BRUNSWICK STEAM ELECTRIC PLANT, UNIT NOS. 1 AND 2
DOCKET NOS. 50-325 AND 50-324/LICENSE NOS. DPR-71 AND DPR-62
RESPONSE TO REQUEST FOR ADDITIONAL INFORMATION RELATED
TO BULLETIN 96-02, "MOVEMENT OF HEAVY LOADS OVER SPENT FUEL, OVER FUEL IN
THE REACTOR CORE, OR OVER SAFETY-RELATED EQUIPMENT"
(TAC NOS. M95562 AND M95563)

ENCLOSURE 1

BRUNSWICK STEAM ELECTRIC PLANT, UNIT NOS. 1 AND 2
NRC DOCKET NOS. 50-325 AND 50-324
OPERATING LICENSE NOS. DPR-71 AND DPR-62
RESPONSE TO REQUEST FOR ADDITIONAL INFORMATION RELATED
TO BULLETIN 96-02, "MOVEMENT OF HEAVY LOADS
OVER SPENT FUEL, OVER FUEL IN THE REACTOR CORE,
OR OVER SAFETY-RELATED EQUIPMENT"
(TAC NOS. M95562 AND M95563)

ATTACHMENT G
Page 1 of 1
Safe Load Paths
Refuel Floor

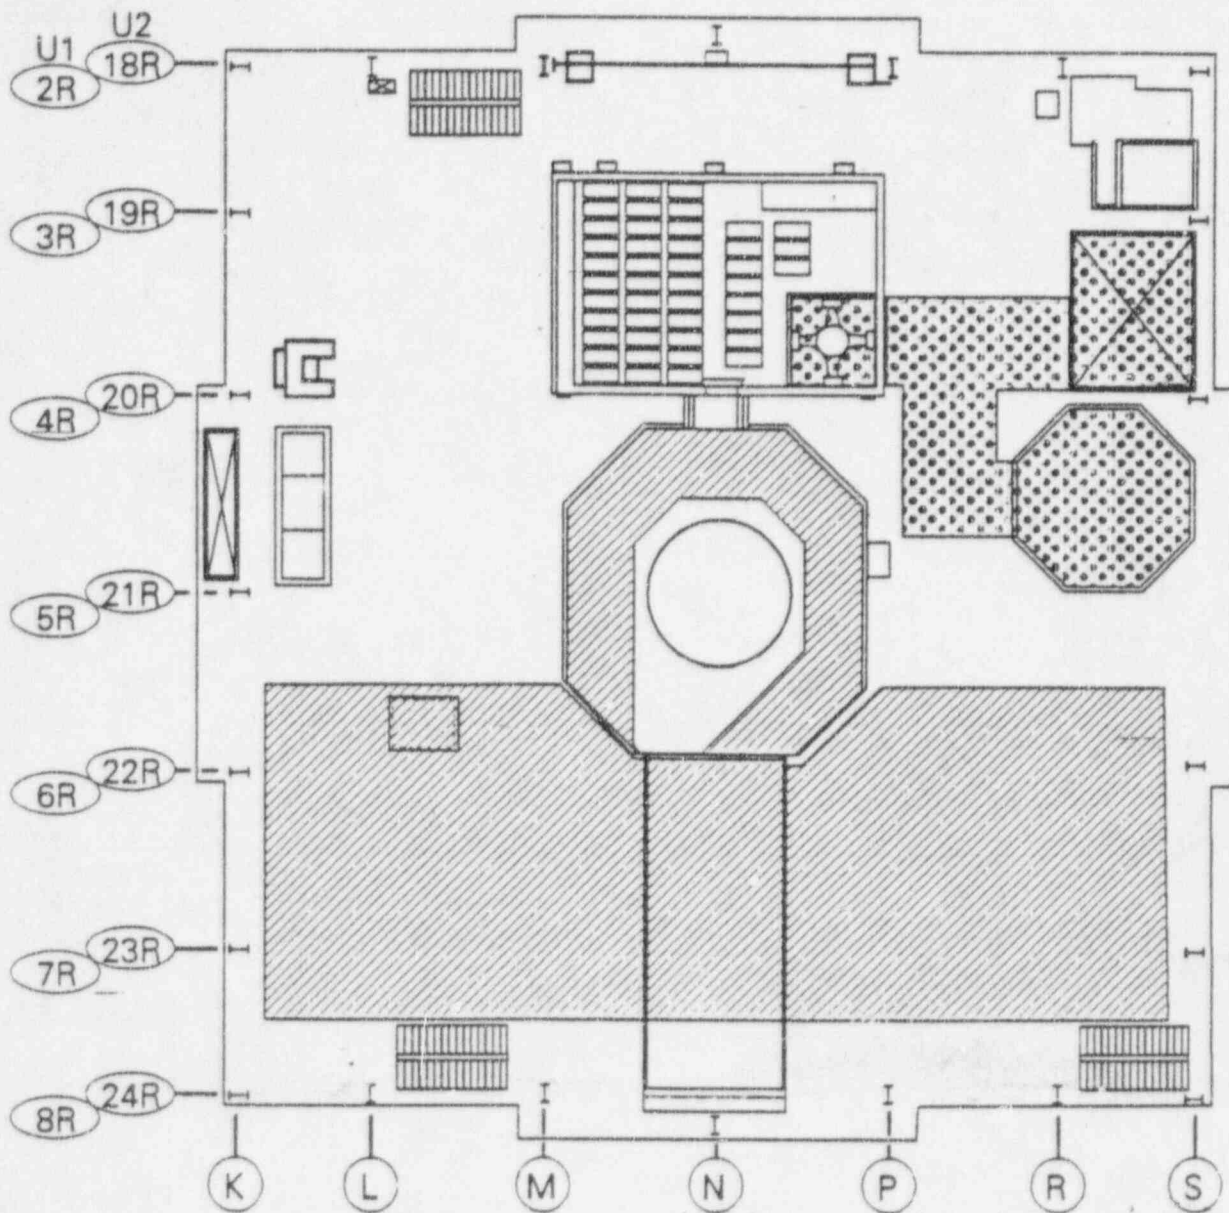
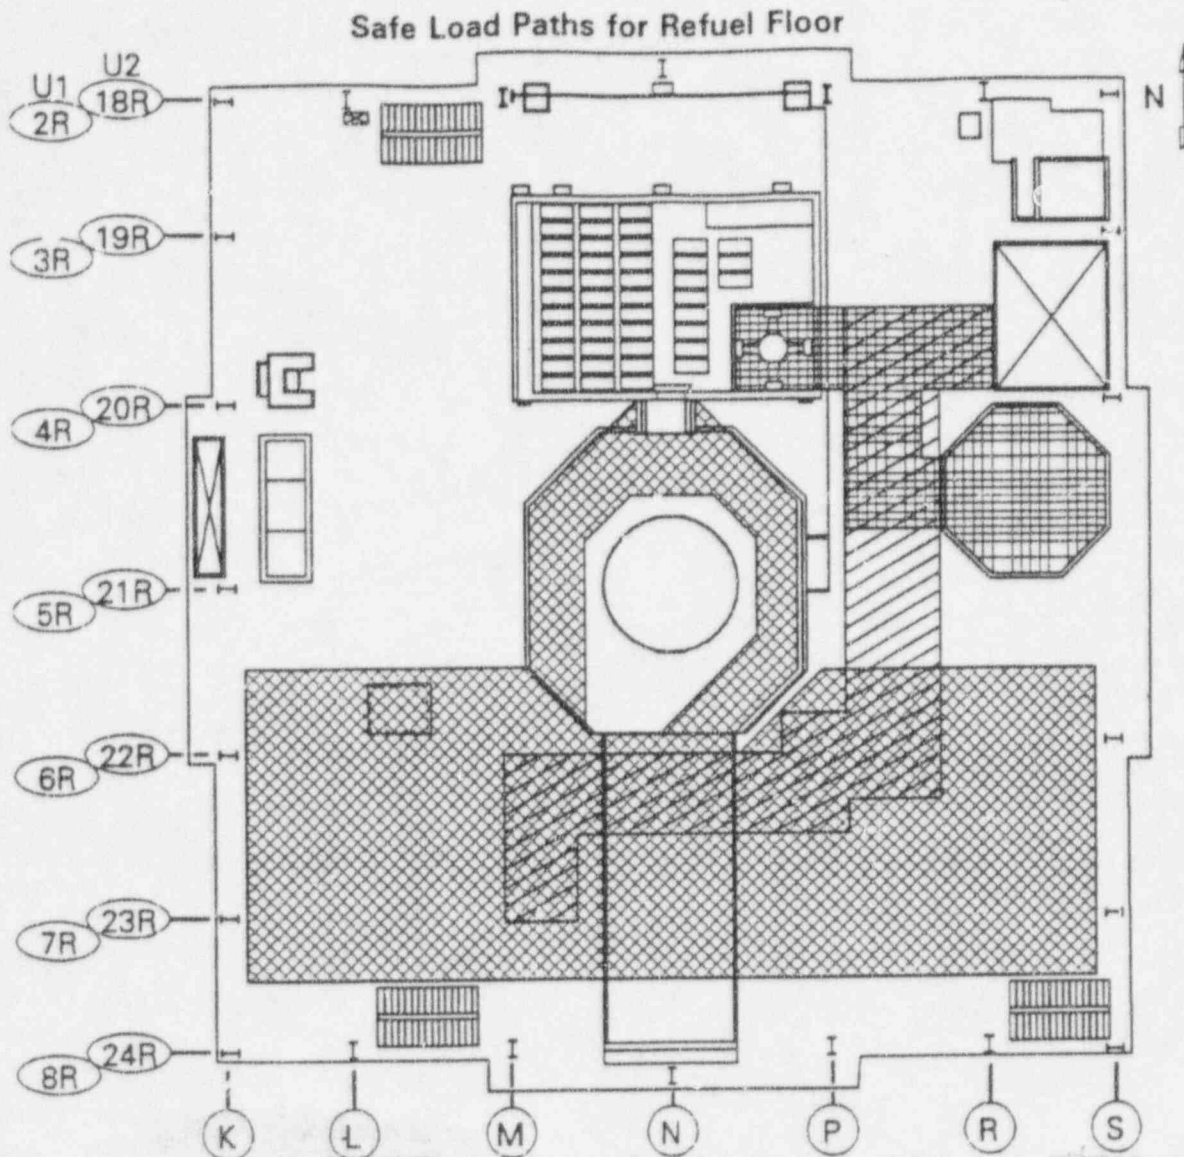
Subsequently, by letter dated December 6, 1996, the NRC staff requested that CP&L provide an evaluation of the Brunswick Plant crane design, load path, and cask loading and unloading processes that support a determination that the scenario described in the December 6, 1996 letter is not credible at the Brunswick Plant. If the scenario described in the letter should be determined to be credible, the NRC staff requested that CP&L also provide responses to several additional questions. The Company has reviewed the potential cask drop scenario described in the December 6, 1996 letter for applicability to the Brunswick Plant and determined that the scenario is not credible for the Brunswick Plant. This determination is based on an evaluation of the Brunswick crane design, load path, and cask loading and unloading processes. Additional information pertaining to the Company's evaluation is provided in Enclosure 1.

In a letter dated December 6, 1996, the NRC staff requested that Carolina Power & Light Company (CP&L) provide an evaluation of the Brunswick Steam Electric Plant (BSEP) crane design, load path, and cask loading and unloading processes that support a determination that the scenario described in the letter is not credible at the Brunswick Plant. If the event is determined to be credible, the NRC staff requested that CP&L provide the following:

In the November 16, 1982 response to the NRC regarding Control of Heavy Loads, CP&L submitted a safe load path (Dwg. 81020-M-001, Sht. 3 of 3) for the handling of spent fuel shipping cask in the Reactor Building. This safe load path was developed to meet the requirements of NUREG-0612, Section 5.1.1(1). This load path was reviewed and accepted by the NRC staff's Technical Evaluation Report/Safety Evaluation contained in the May 18, 1984 letter. Site Procedures OE&RC-0582, "Handling the IF-300 Cask" (Reference 4) and OMMM-015, "Operation and Inspection of Cranes and Material Handling Equipment" (Reference 5) provide the current Brunswick Plant safe load paths. The current Brunswick Plant safe load paths for the spent fuel pool shipping cask are the same as the original safe load paths provided to the NRC staff. Copies of the three load paths are attached for reference (see Exhibit 1).

The Brunswick safe load path and the crane design are consistent with Updated Final Safety Analysis Report section 9.1.4.2.2, which states:

in traversing the path from the access hatch to its resting position in the pool, the cask at no time passes over any other part of the fuel pool. As a backup to operator action, limiting stops in the crane control system prevent unwanted travel over spent fuel, as recommended in Regulatory Guide 1.13, Fuel Storage Facility Design Basis.
